COASTSIDE FIRE PROTECTION DISTRICT

ADDENDUM NO. 1

Dated Tuesday, October 7, 2026

FIRE STATION #44 REPLACEMENT PROJECT

1 FIRST FLOOR POWER PLAN
SCALE: 1/8" = 1'-0"

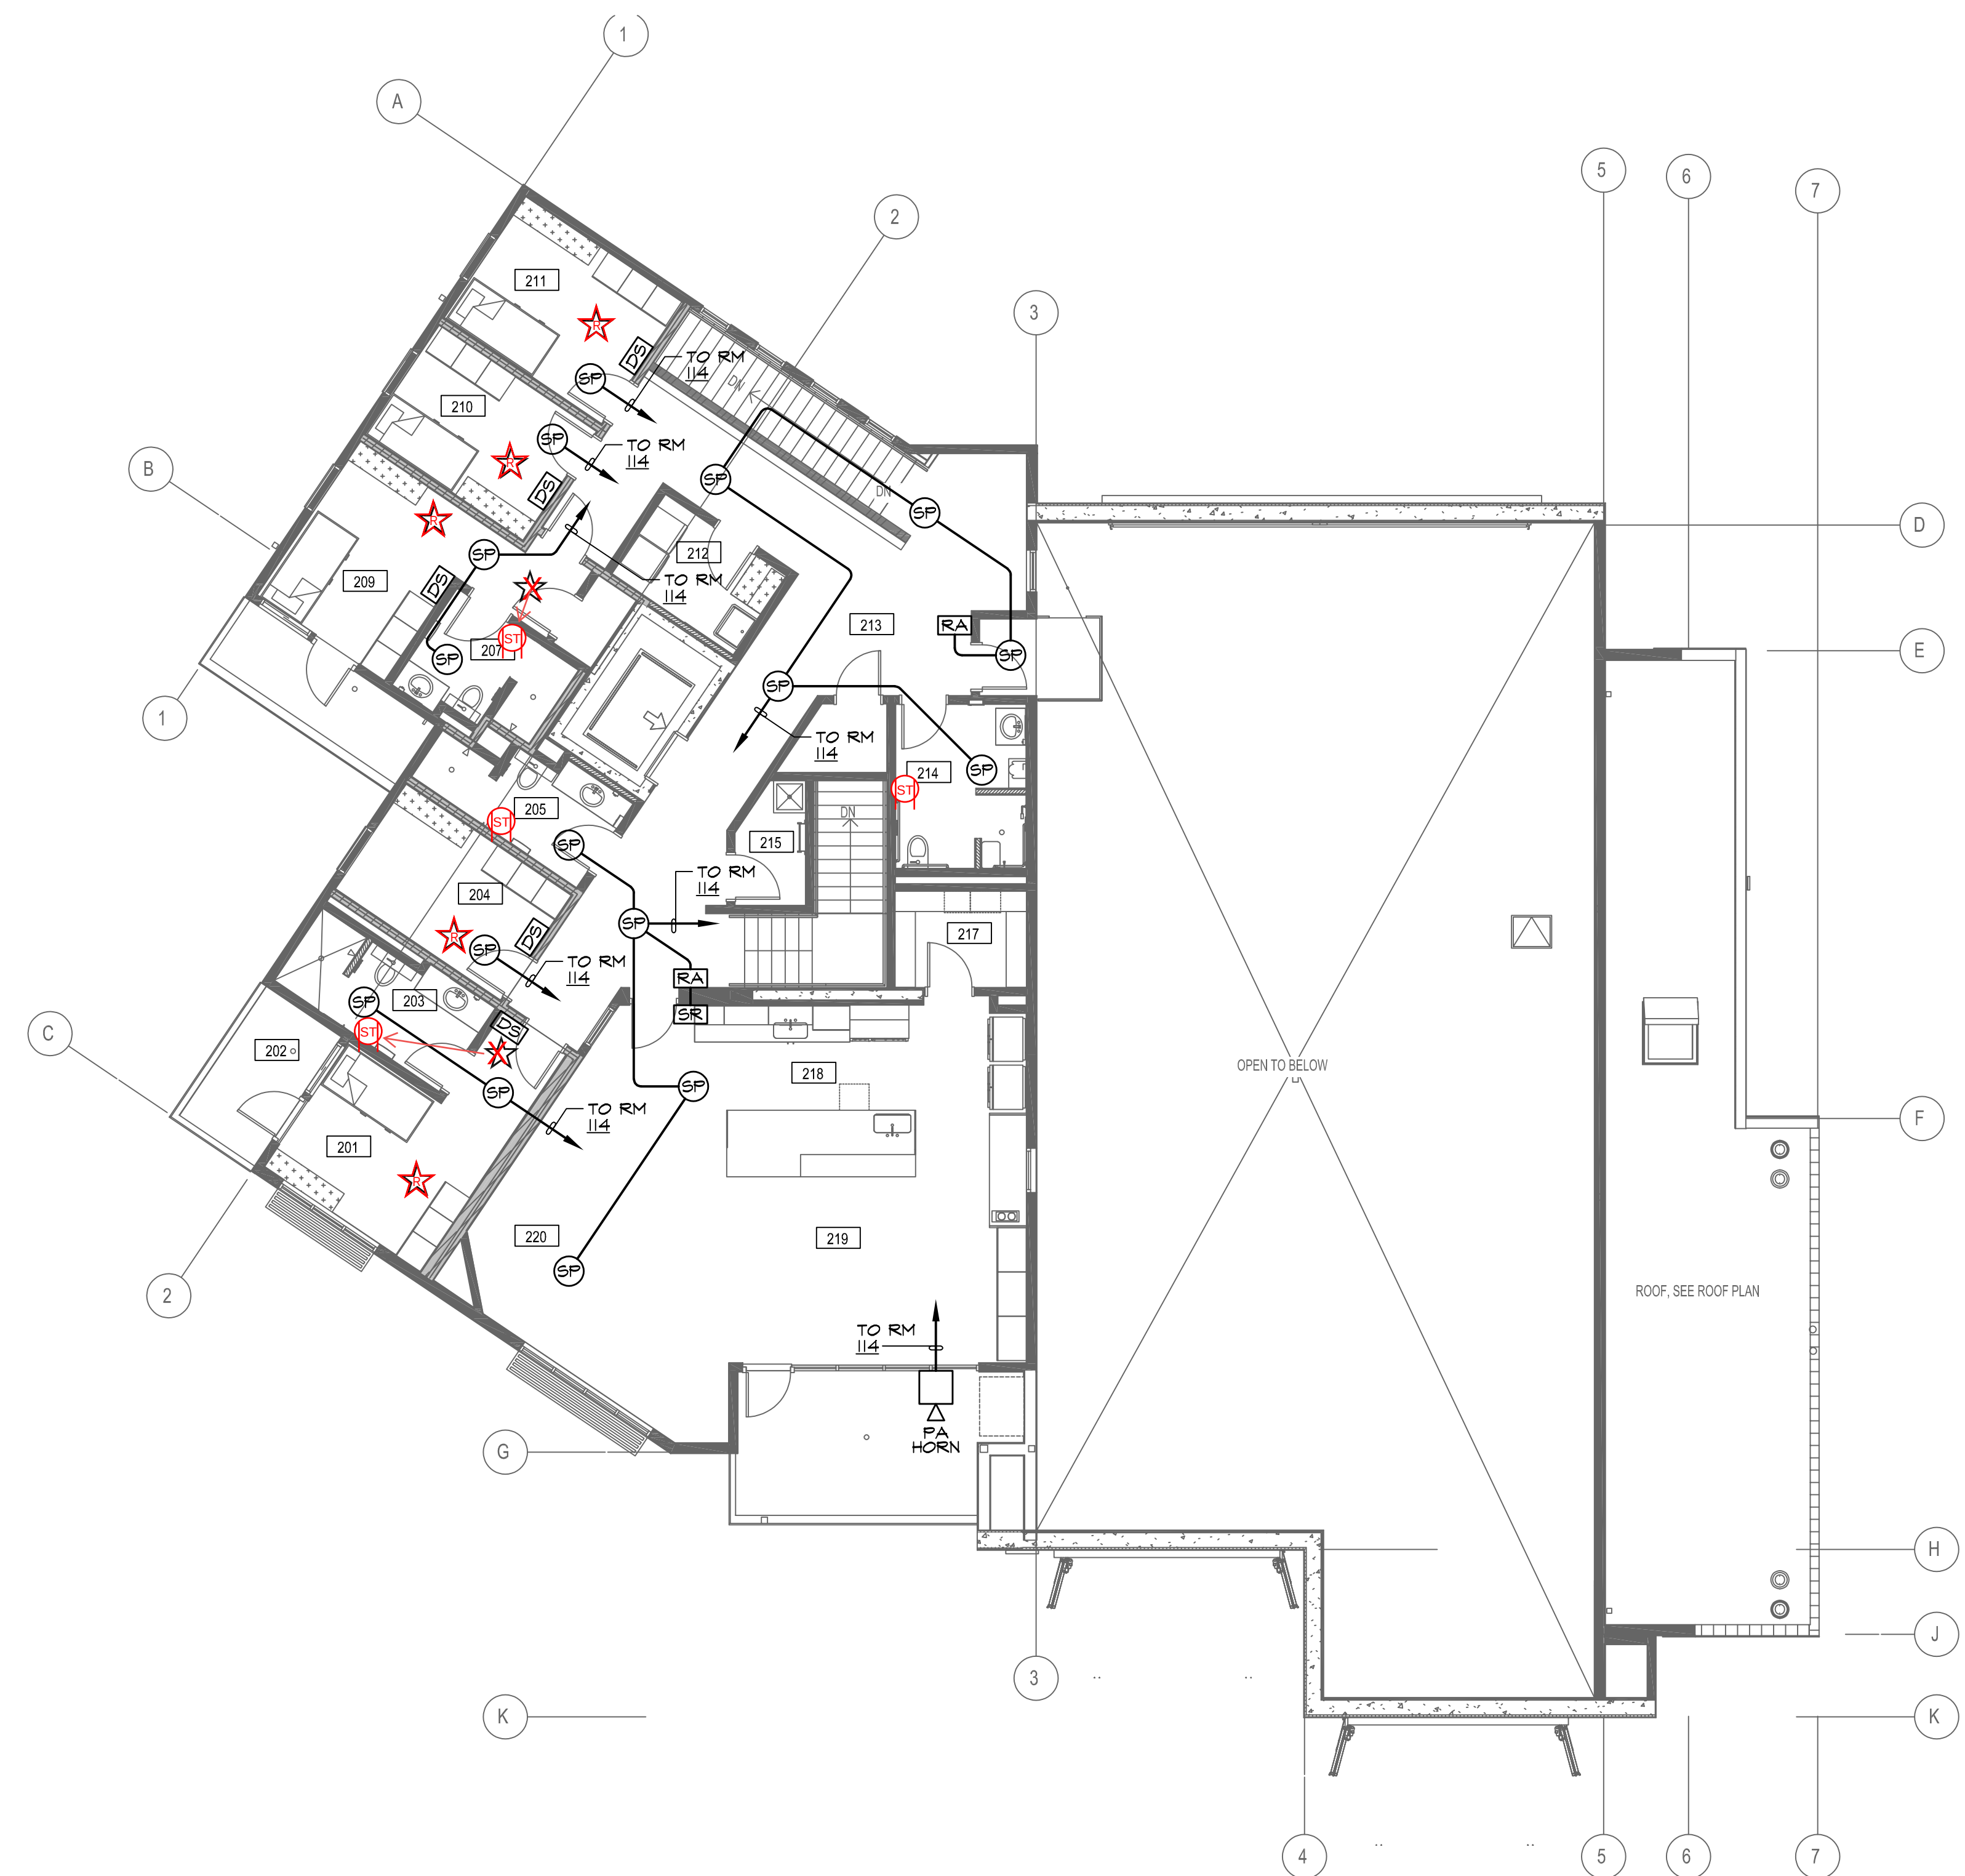
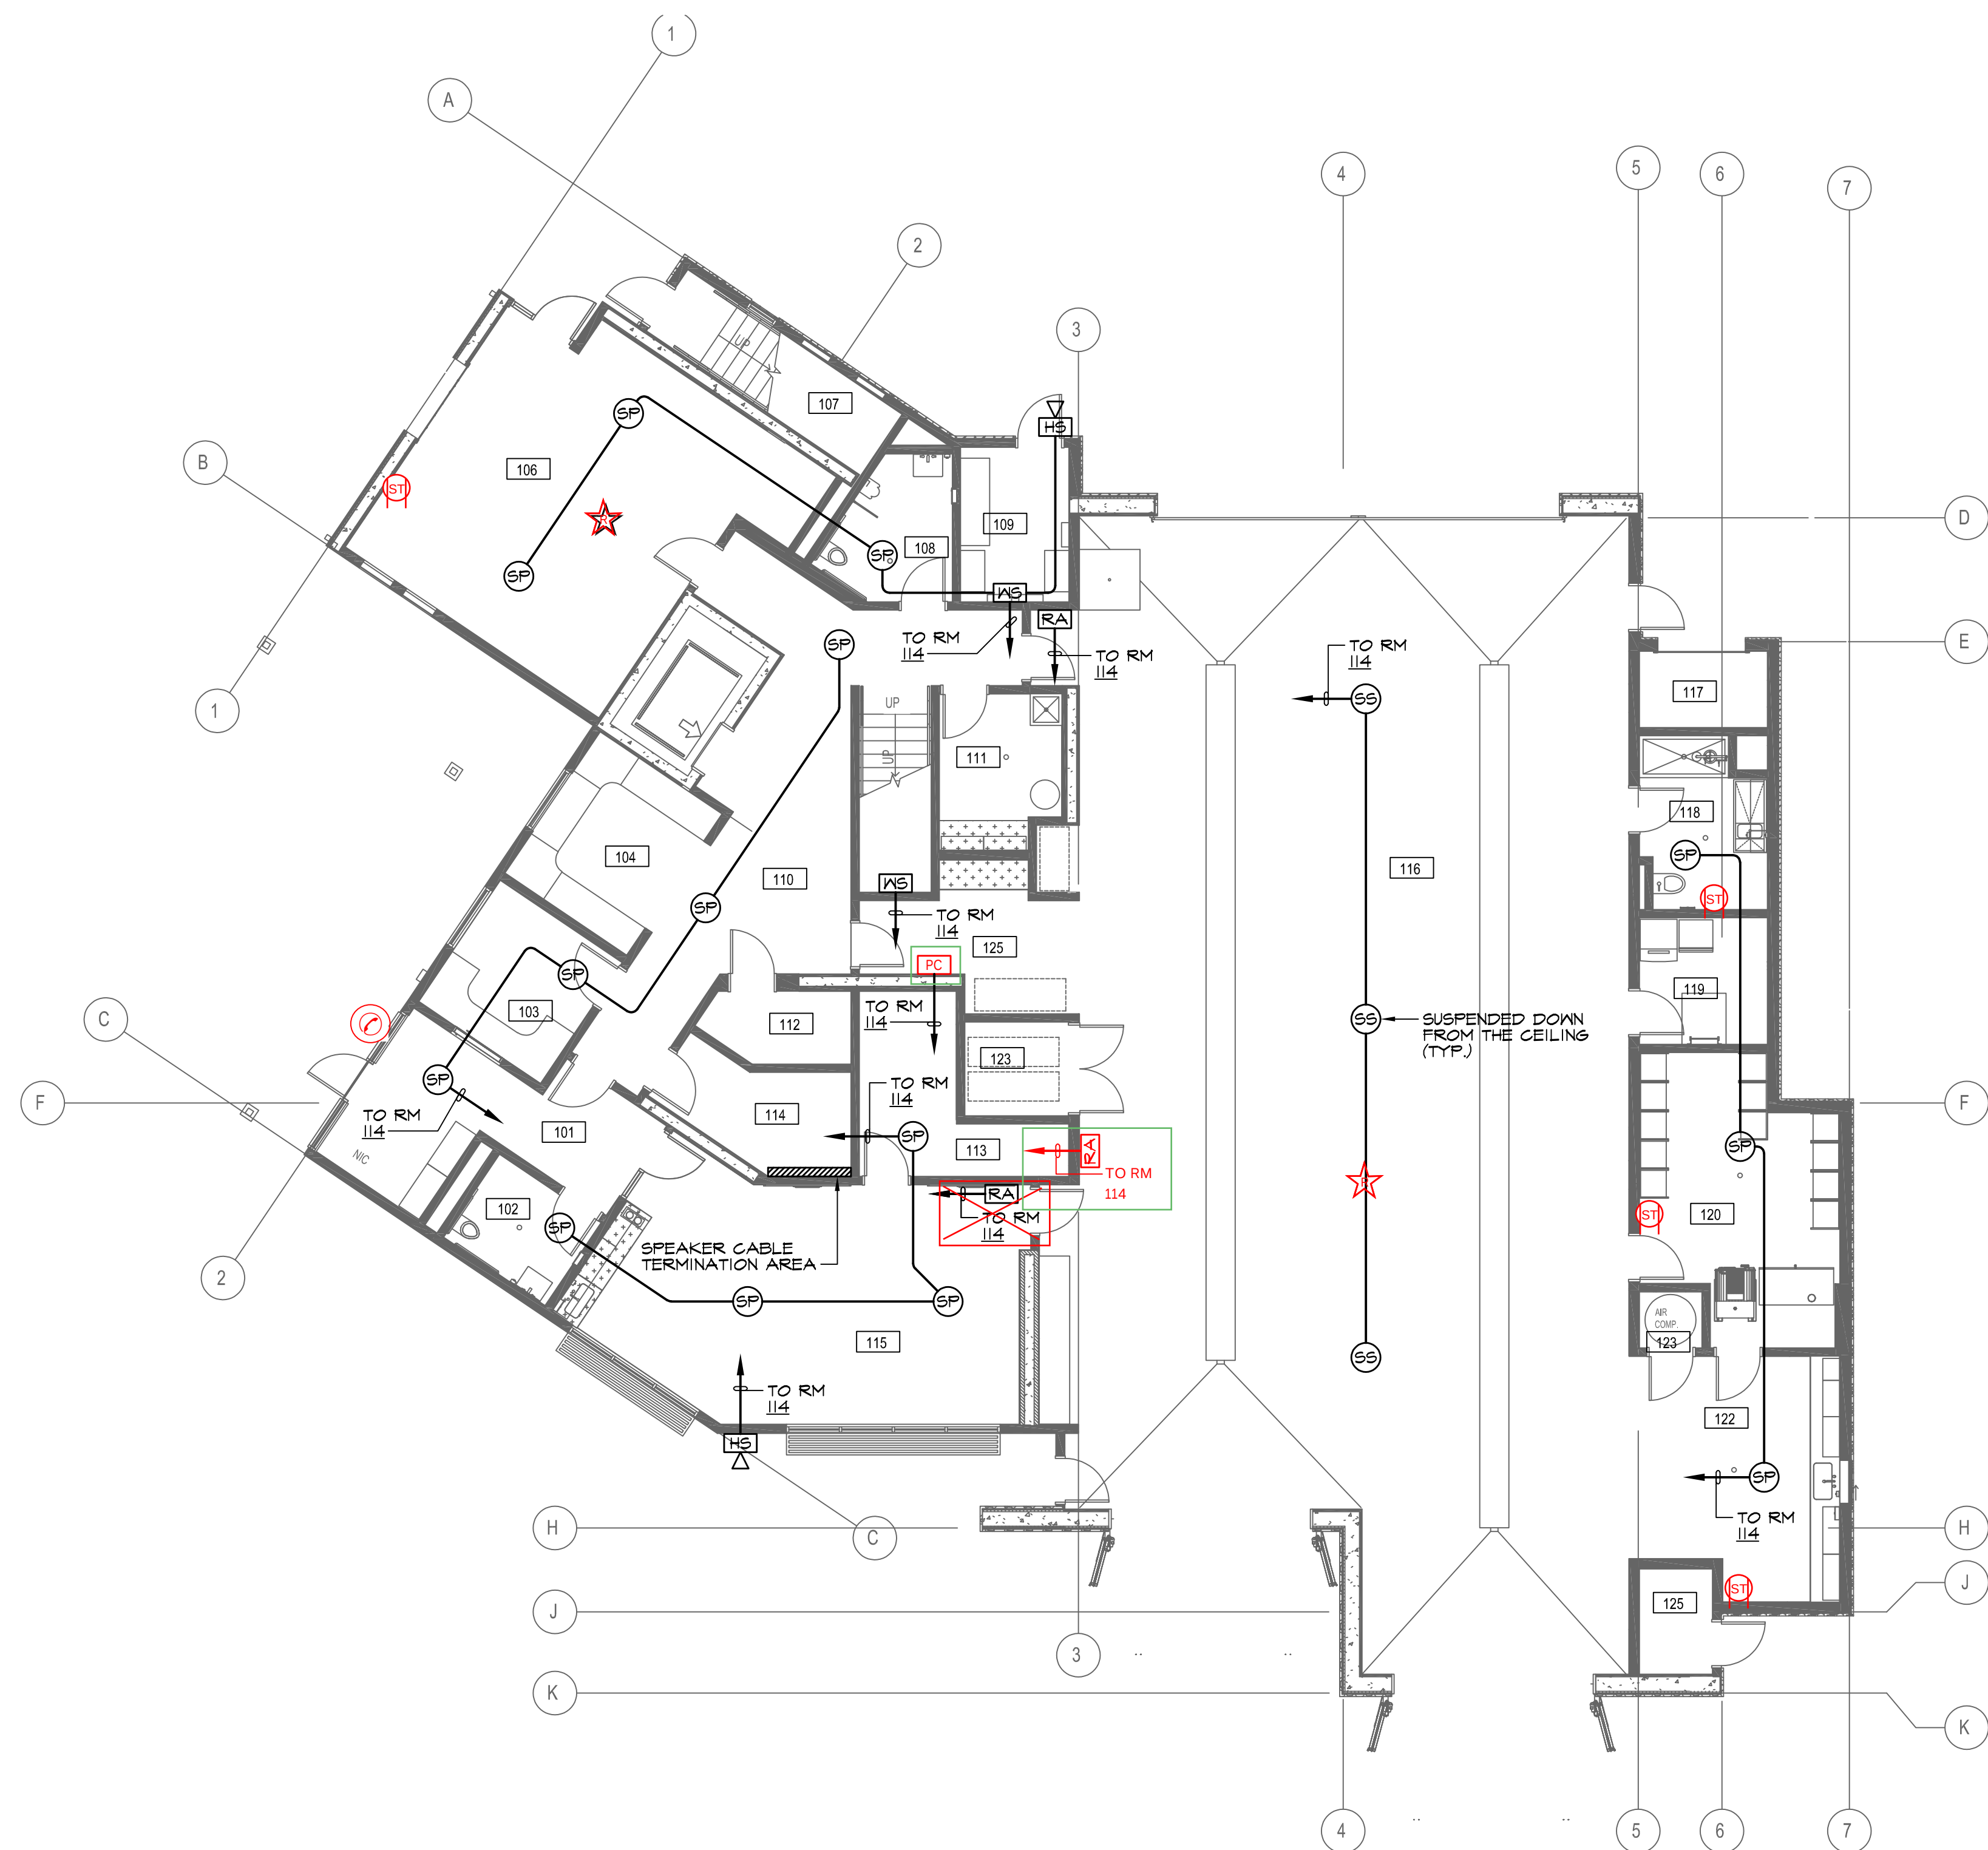
The alerting plan sheet E2.5 has been revised. The revised sheet is **attached** to this addendum. The revised sheet supersedes the original version of sheet E2.5 issued with the bid.

1 DEMOLITION SITE PLAN

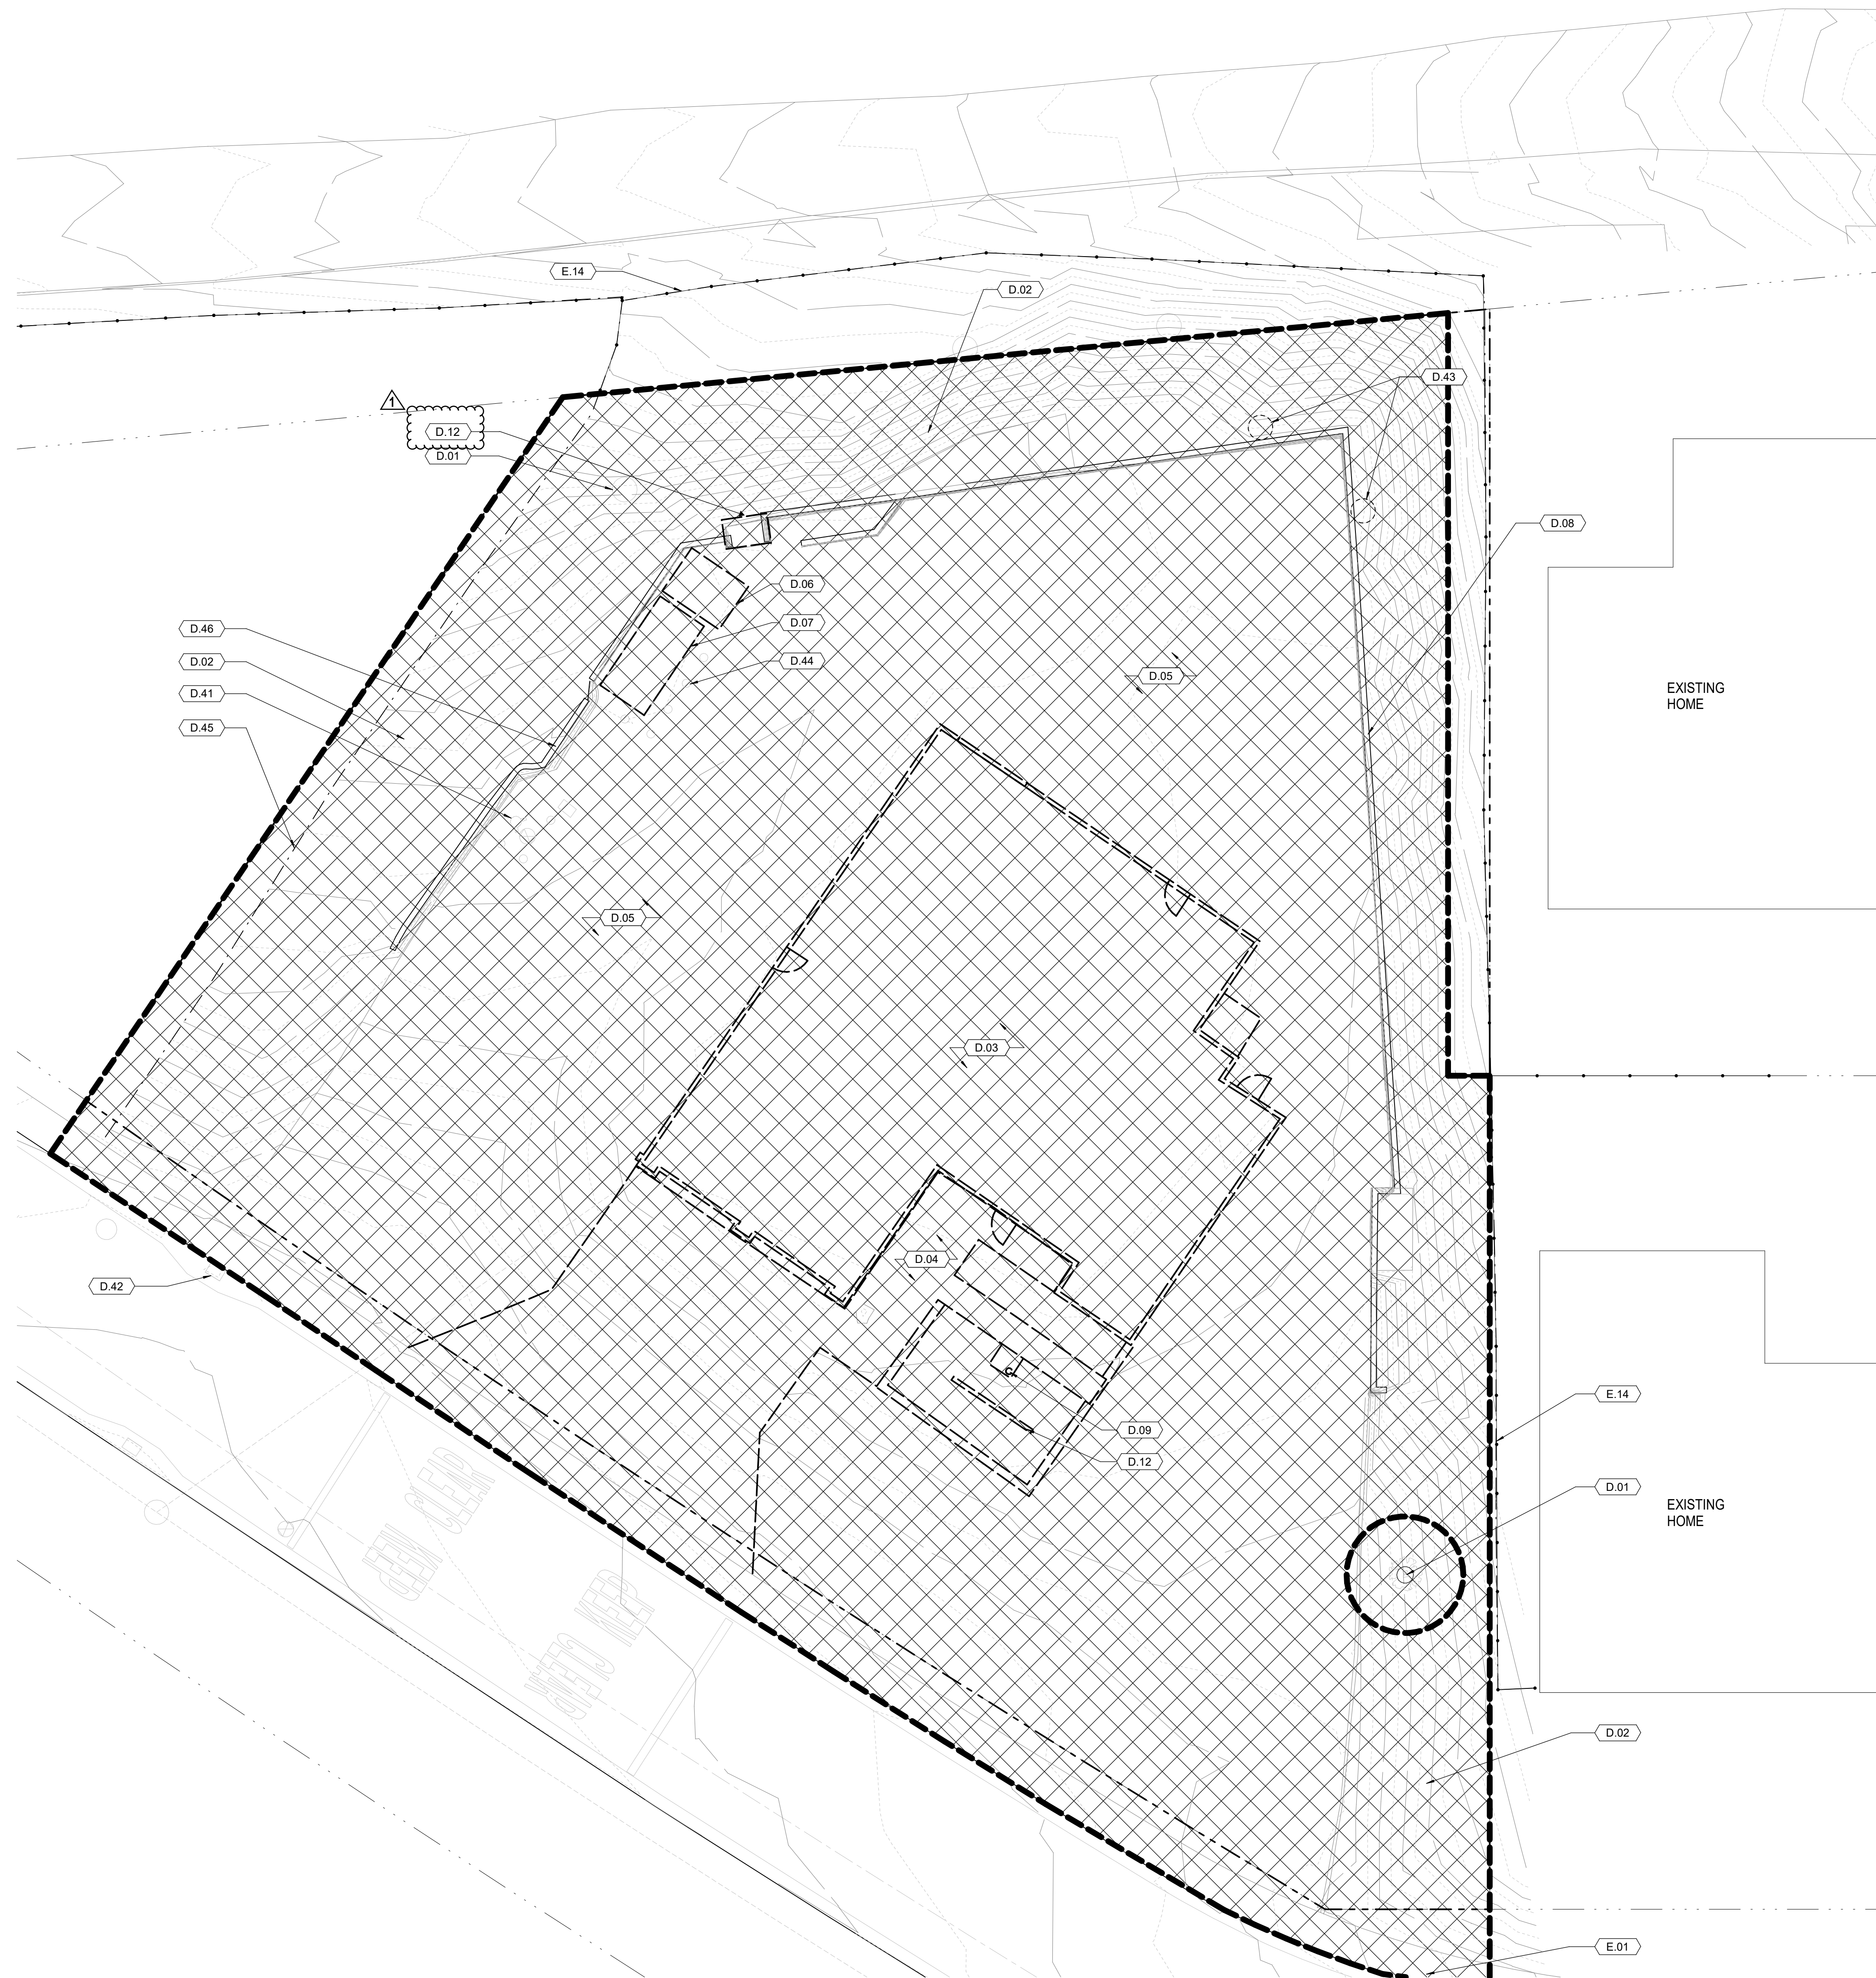
The District would like the Contractor to salvage the aboveground fuel tank, generator, and air compressor on the site and deliver them to the District at 1191 Main Street, Half Moon Bay, CA 94019. Sheet D1.1 (Demolition Site Plan), Fuel Tank Note has been revised to the clouded "Salvaged Items" note in the **attached** revised Sheet D1.1, which supersedes the original version of sheet D1.1.

SALVAGED ITEMS:

- NOTE: THE FOLLOWING ITEMS ARE TO BE SALVAGED AND RETURNED TO THE DISTRICT AT 1191 MAIN STREET, HALF MOON BAY, CA 94019

1. GENERATOR
2. FUEL TANK
3. AIR COMPRESSOR
